STAFF REPORT

CITY COUNCIL
DATE: 01/19/2021

TO: Mayor and City Council
FROM: Ken Roberts, Planning Director
AGENDA ITEM: **Schiltgen Farms Revised PUD Concept Plan (10880 Stillwater Boulevard)**
REVIEWED BY: Ken Roberts, Planning Director
Ben Prchal, City Planner
Jack Griffin, City Engineer
Frank Ticknor, Washington County Design Engineer

3 OF 3

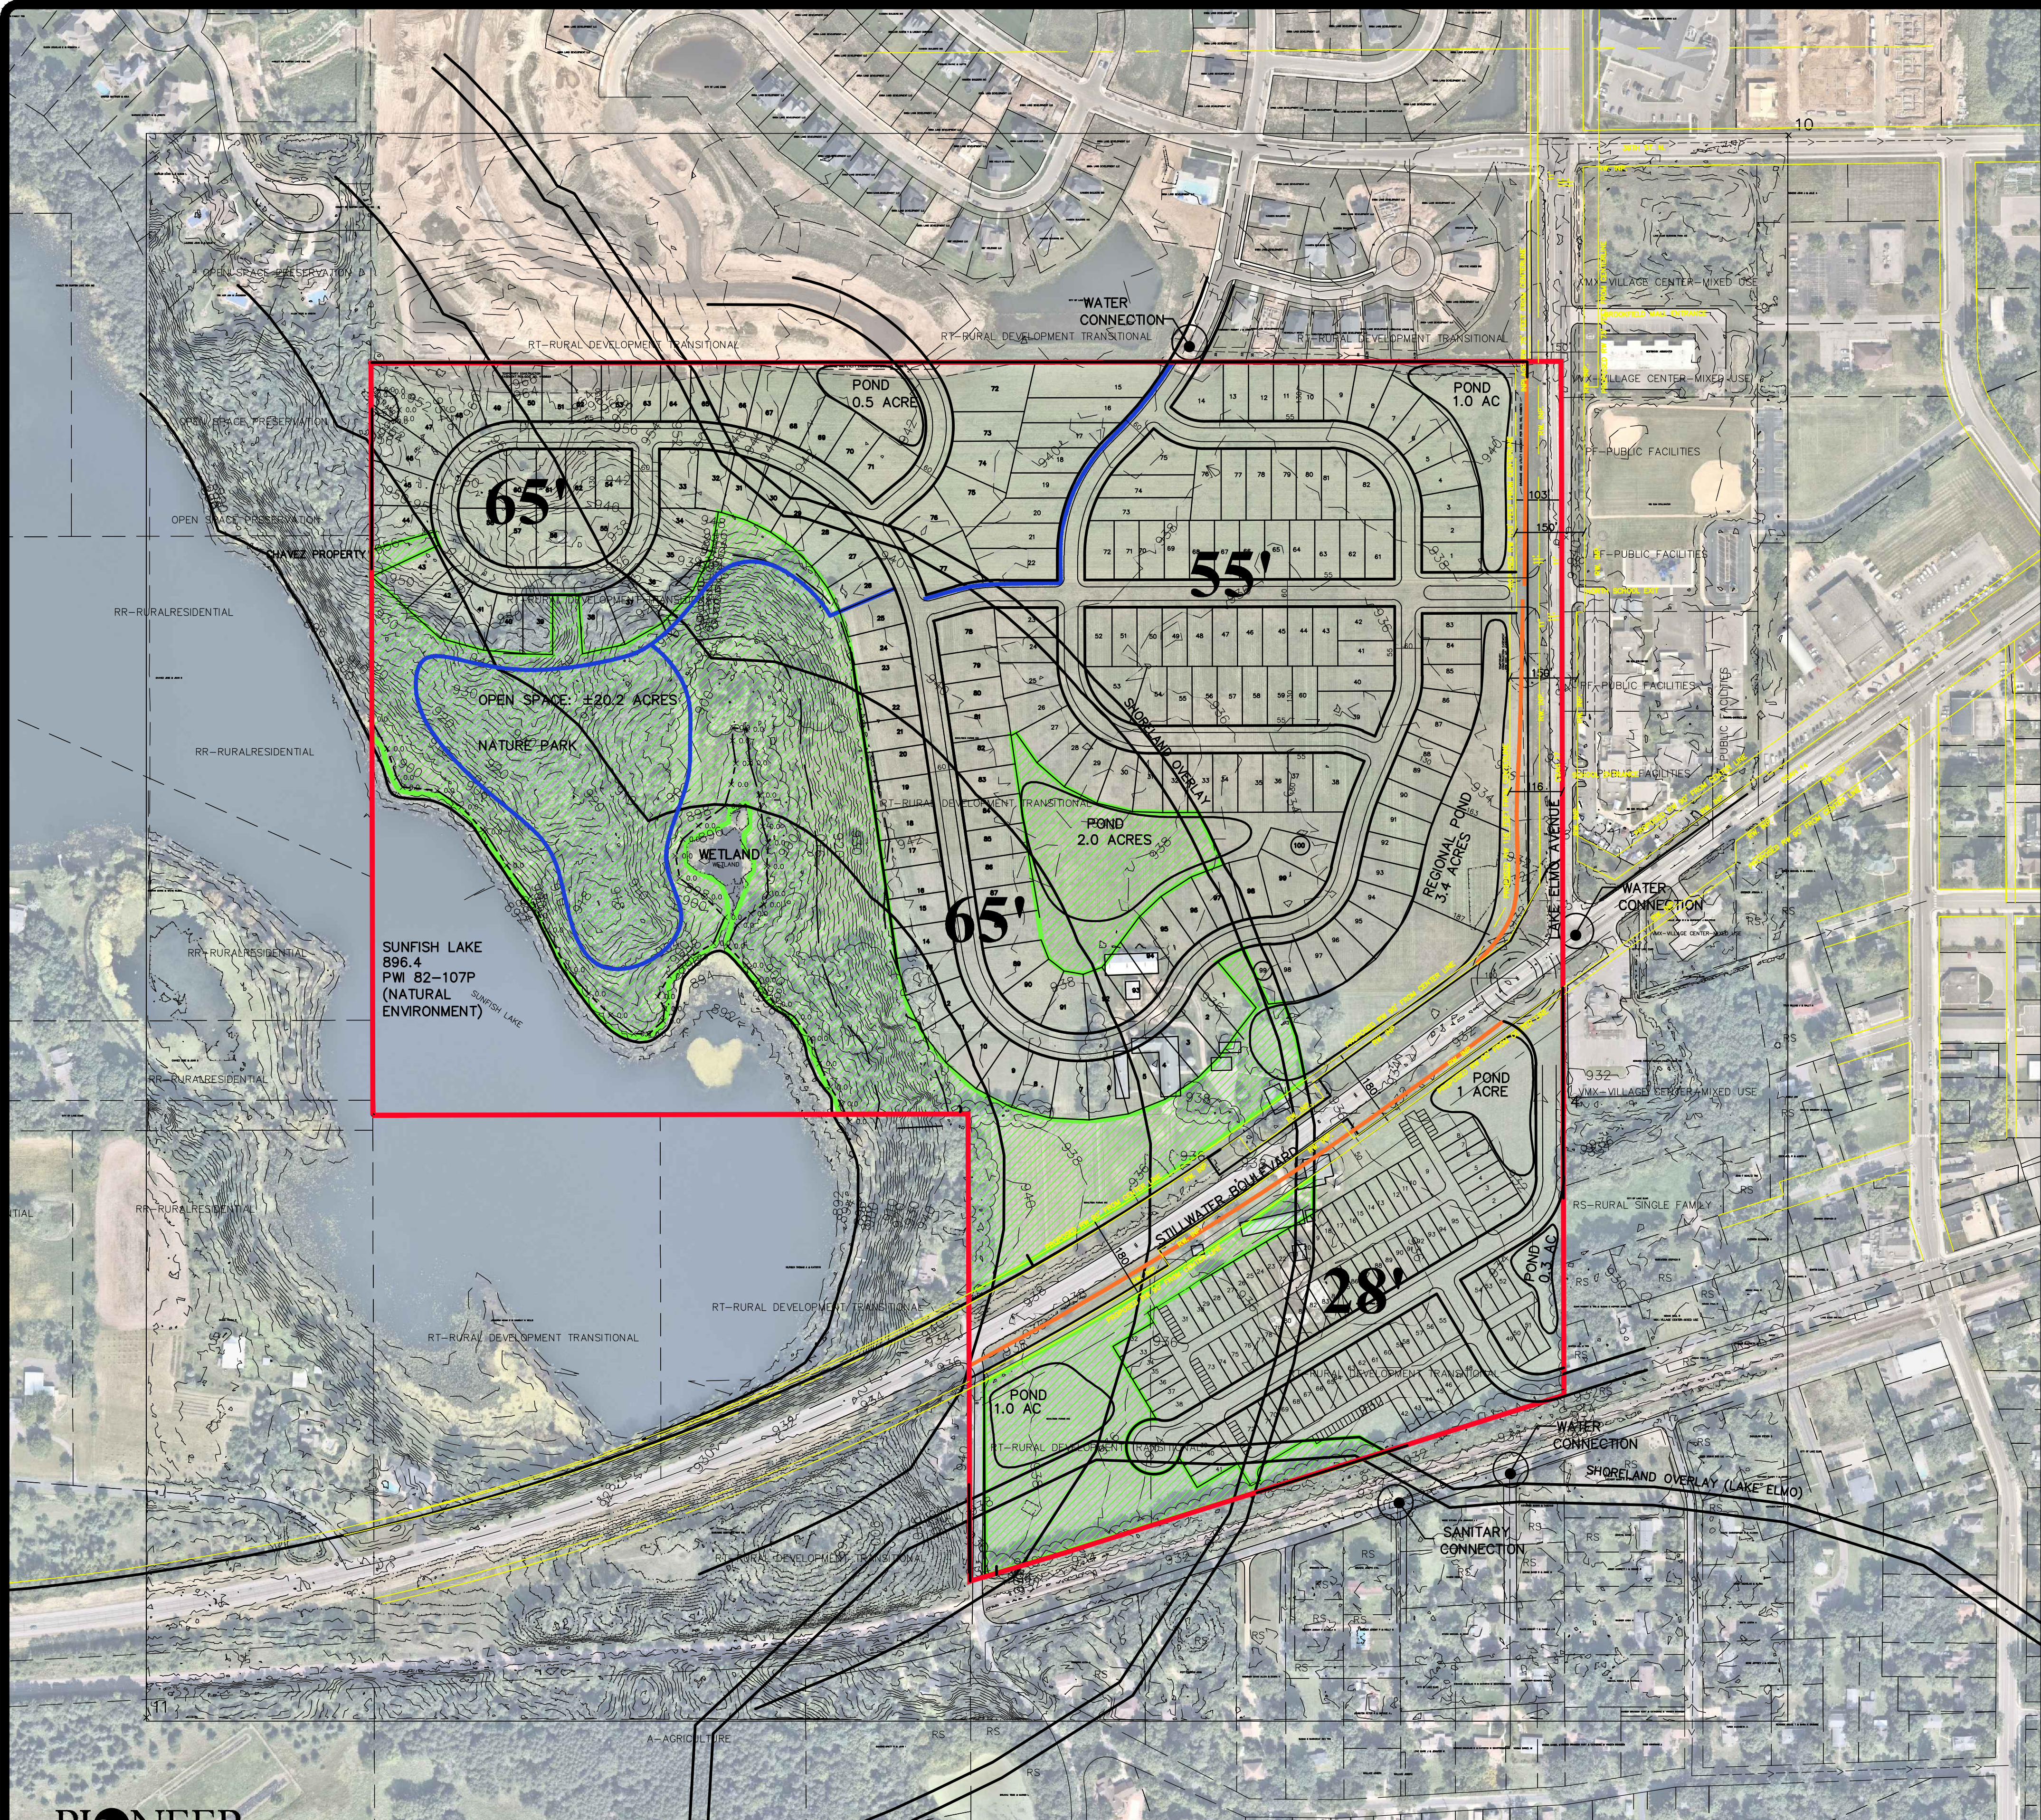
- Adaptive Reuse – 5 points = 5% increase in density
Significant renovation, rehabilitation and adaptive reuse of an existing building(s), rather than demolition. **Note:** The latest PUD concept plan, dated January 7, 2021, shows the developer saving part of the existing barn facing Stillwater Boulevard as part of an HOA amenity with open space surrounding the barn and a small parking area and trail system adjacent to it.

Barn Preservation. The developer noted in its project narrative that they exploring options for preserving part of the barn. The latest concept plans (dated January 7, 2021) show part of the existing barn facing Stillwater Boulevard being preserved with a small parking area and a trail connection in an HOA owned open space area. The City should require the applicant to provide more design details about the potential barn preservation and use (including any off-street parking) with any submittal for preliminary PUD/plat approval. I would expect that if the developer is able to preserve some of the barn that it would be located in a common area owned and maintained by the HOA.

The City Engineer is recommending the City require the developer revise the proposed street plans to delete the cul-de-sac and continue the public street through the site to make a connection to Klondike Avenue. The latest concept plan shows this future street connecting to Klondike Avenue as was suggested by City staff. This street connection would provide an alternate primary access to the development area south of Stillwater Boulevard before the construction of the future roundabout. This street connection will require the developer to make improvements to Klondike Avenue to meet current City street standards together with turn lane and intersection improvements at Stillwater Boulevards as recommended by Washington County. There also may be a need for the developer to dedicate additional right-of-way for Klondike Avenue and for the future roundabout. The proposed Concept plans do not show any changes to Klondike Avenue or to the existing railroad crossing.

The proposed plans also show a public street connection to the southeast corner of the site connecting to Upper 33rd Street on the north side of the railroad tracks. This is consistent with City staff recommendations. The remainder of the streets south of Stillwater Boulevard would be 24-foot-wide private driveways that would provide access to the proposed small-lot single family homes (the detached townhouses).
